SWITCH, TELEPRINTER TG.986.

LINE TERMINATING AND TESTING UNIT FOR SMALL OFFICES

TG(L) 986 21.5.36

FIG. 1 WIRING

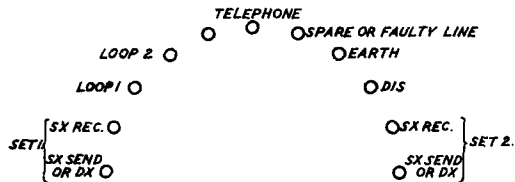
| A | B |
|--|---|
| NOTE 1 ADDED LL WP HAS A 102.9 | |

NOTE 1.
 WHEN A SECOND SWITCH IS FITTED TO ACCOMMODATE LINES 3 AND 4, TAGS 6 OF THE SWITCHES ASSOCIATED WITH LINES 1 AND 2 SHOULD BE CONNECTED TO TAGS 6 OF THE SWITCHES ASSOCIATED WITH LINES 3 AND 4 RESPECTIVELY.

FIG 8. 2 LOOP SIMPLEX CIRCUIT

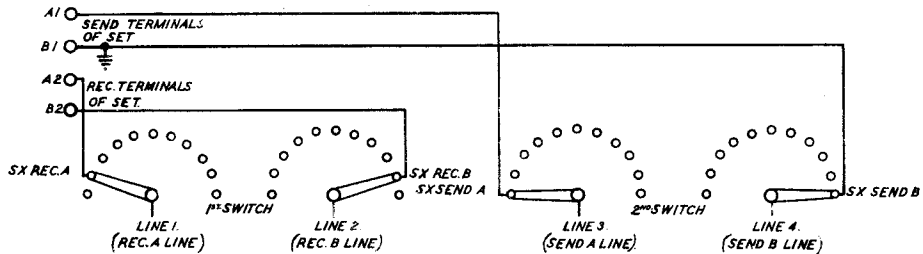
| A | B |
|--|---|
| REDOHMK. FIGS. 3 & 8 ADDED. FIG. 8 BY ROYALNAVY/410. | |

NOTE.
LABELS No. 264 B BLACK TO BE REPLACED BY
LABELS No. 264 A BLACK WHICH SHOULD BE
REQUISITIONED SEPARATELY AND AFFIXED
LOCALLY
